JK-GEN 384-12

ERRATA SHEET

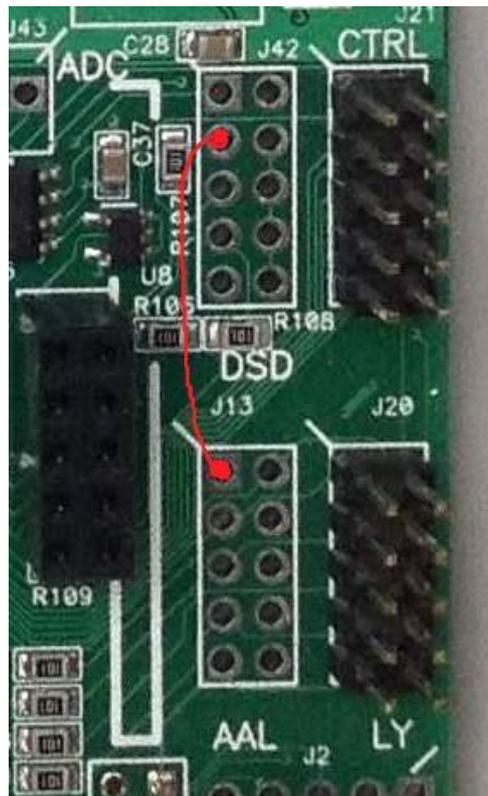
2. Internal MCLK is not always stable at 48/96/192/384 kHz.

Sometimes, the internal main clock is not stable at 48x sample rate scale.
Actually for PCB Rev. 1.3 and 1.3a.

- a) Open the case and check if the wire jumper exists:

If it exists – you do not need to do anything. If it does not exist – continue.

- b) Remove the Main PCB from the case
- c) Cut wire at the bottom side, as shown on a picture below:

- d) Put short wire on the top side, as it shown above.:
